**PUR-1270
ADDENDUM NO. 5
INVITATION TO BID**

CONOCOCHEAGUE TREATMENT PLANT ENR UPGRADE

DATE: Thursday, May 26, 2016

SECTION
 A S-13 SCALE: 3/4" = 1'-0"

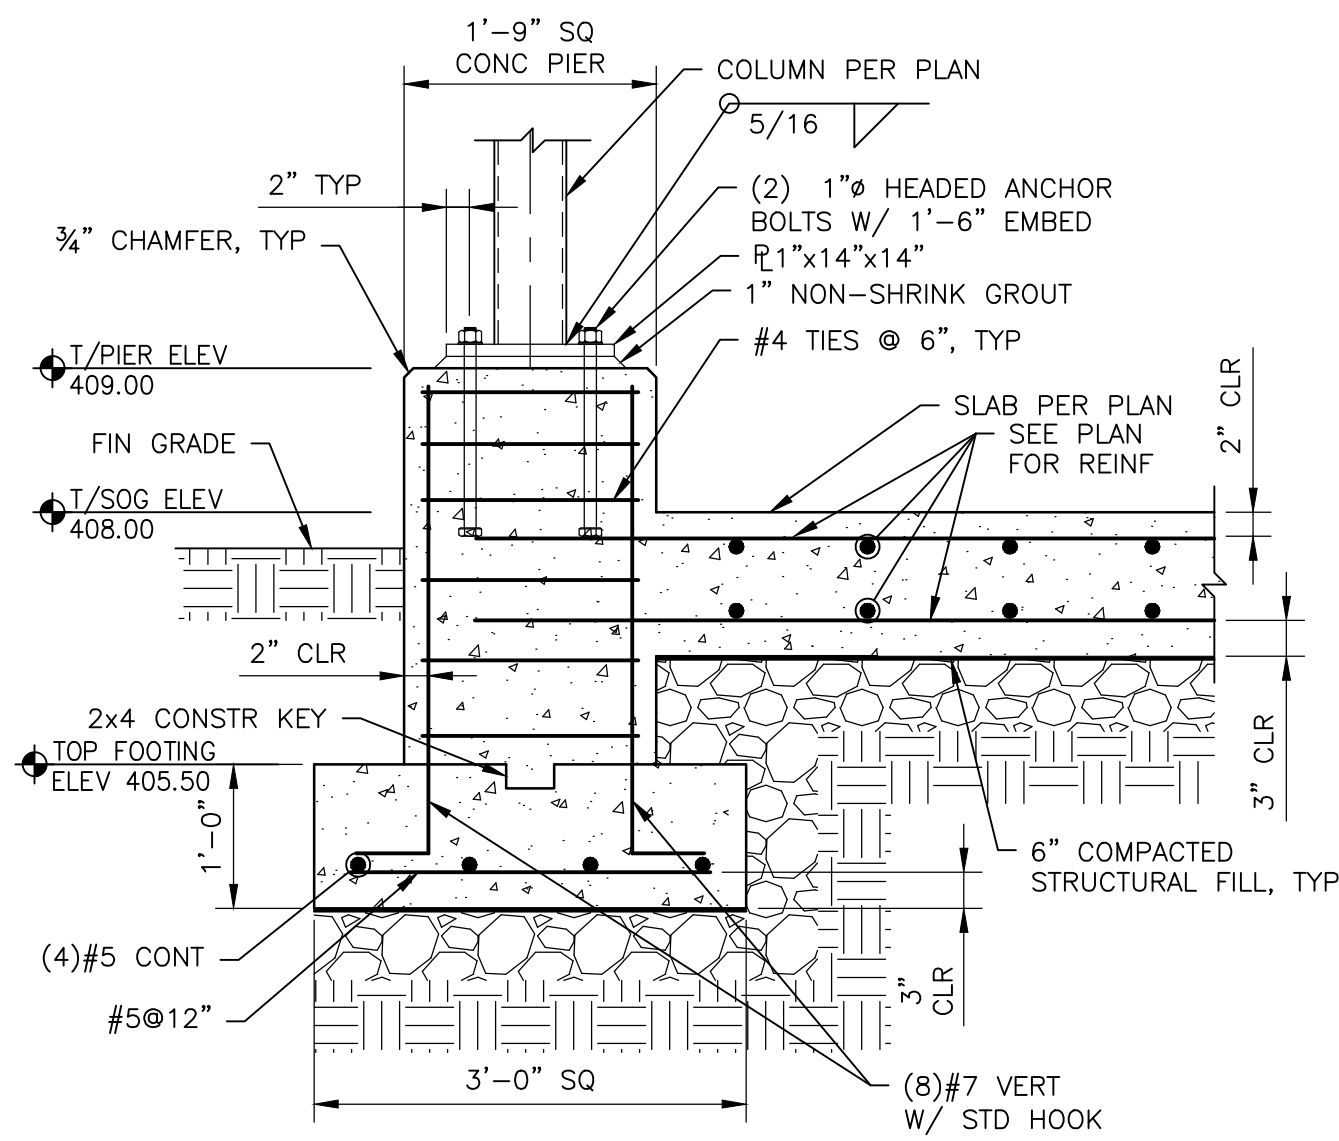
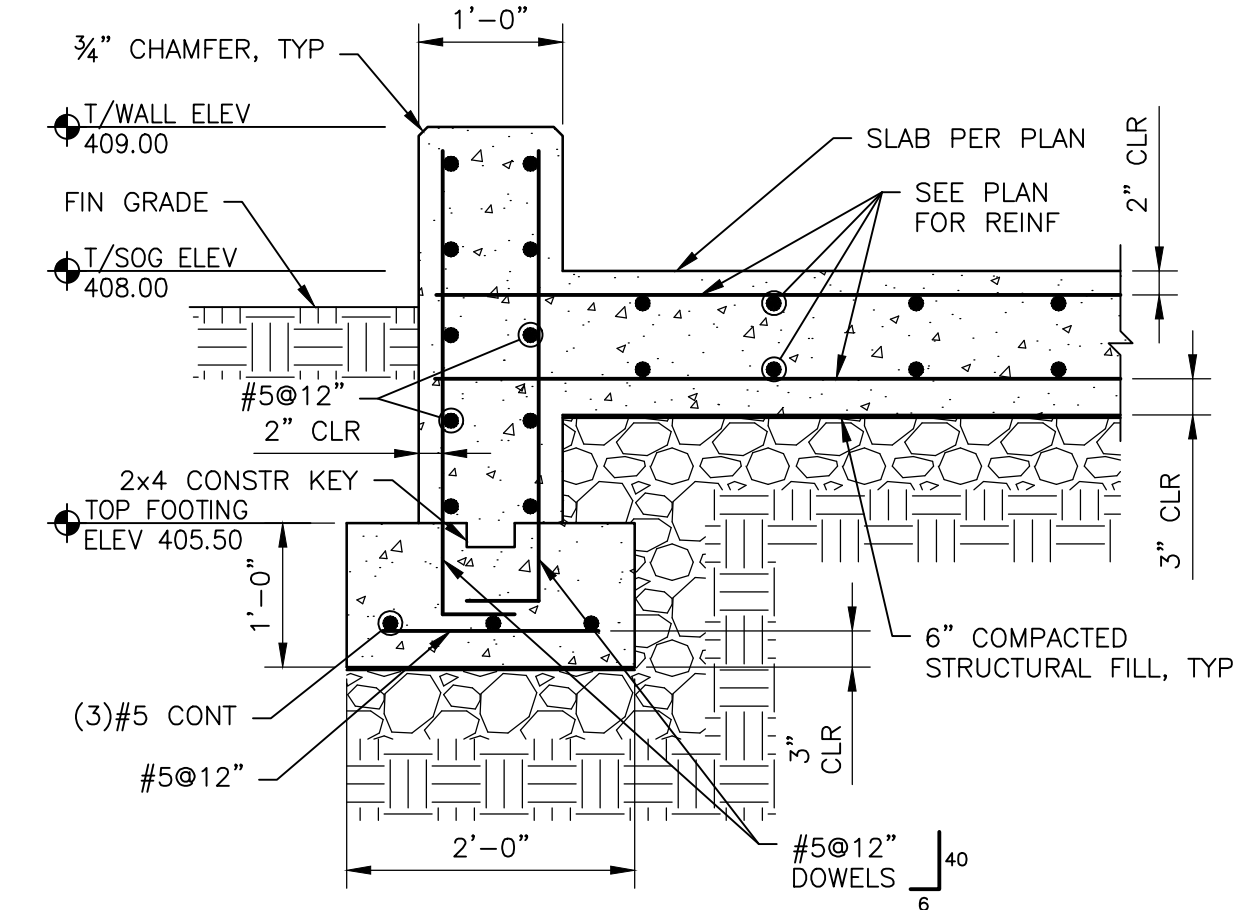
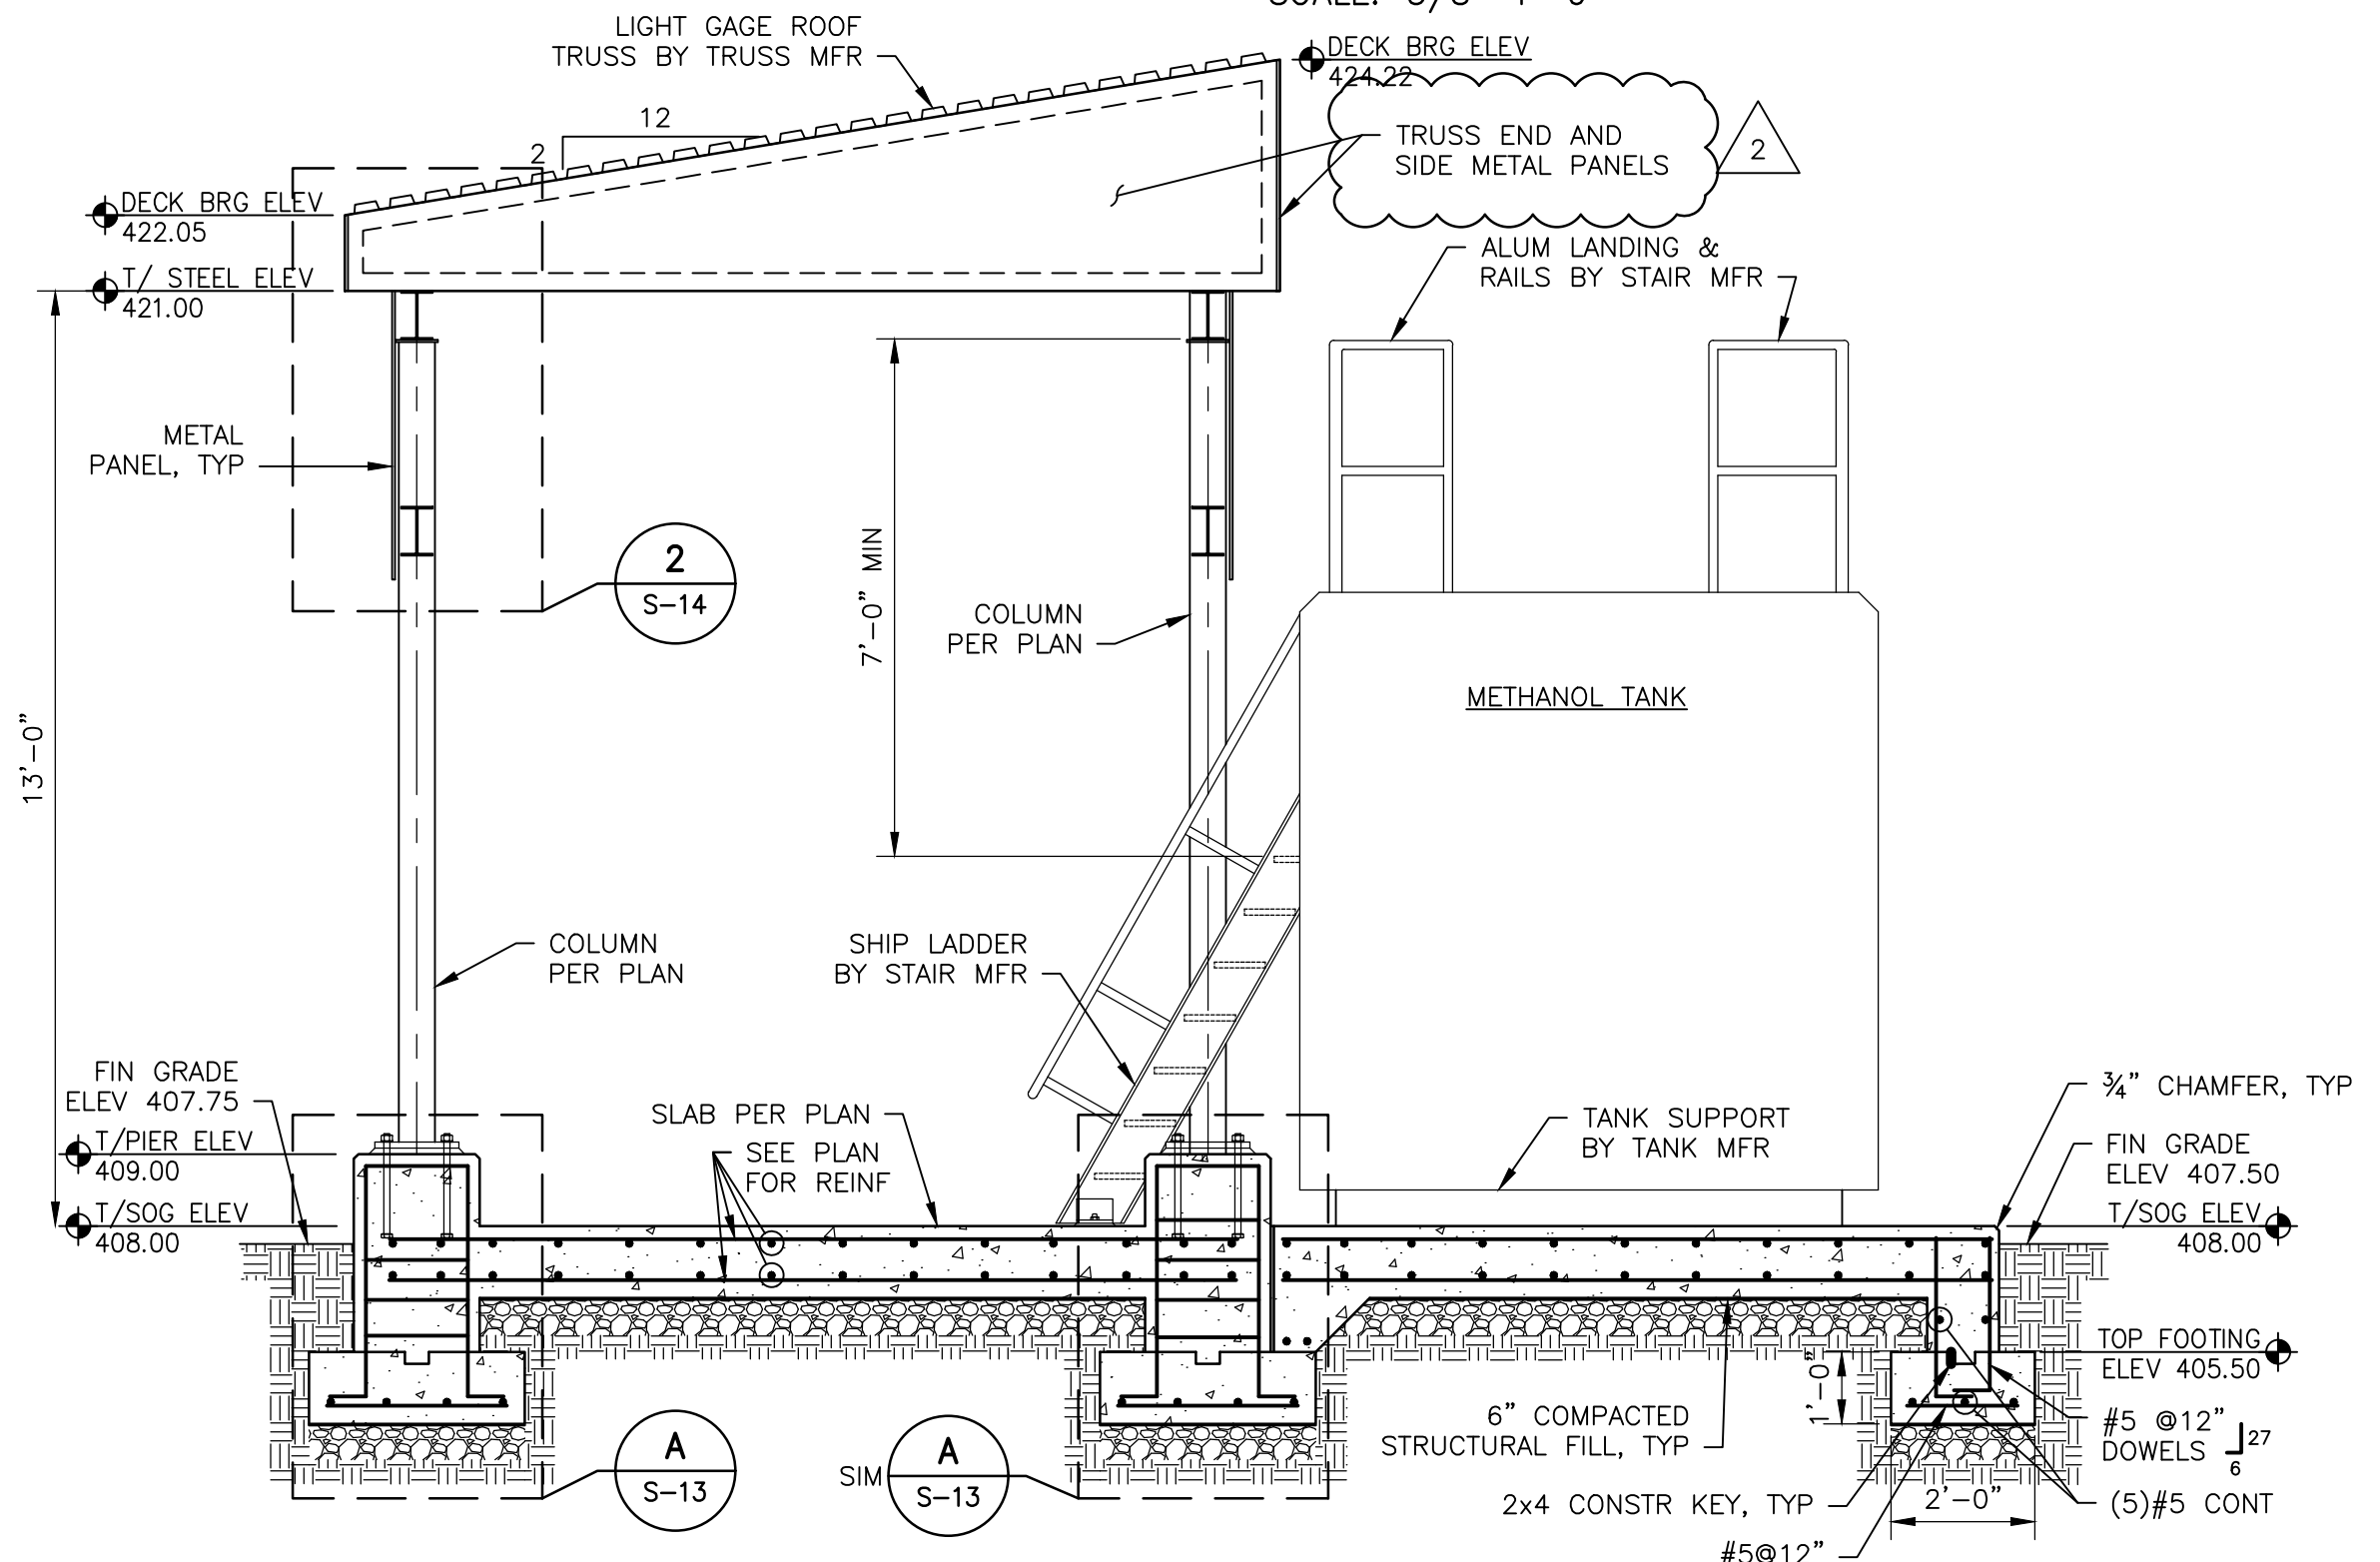
ITEM NO. 5: *Inquiry:* Drawing PM-22 shows a concrete stair outside of the footprint of the Methanol structure with no below grade support. Please provide information for the foundation for this stair.

Response: See revised Sheets S-13 and S-14 attached to this Addendum.
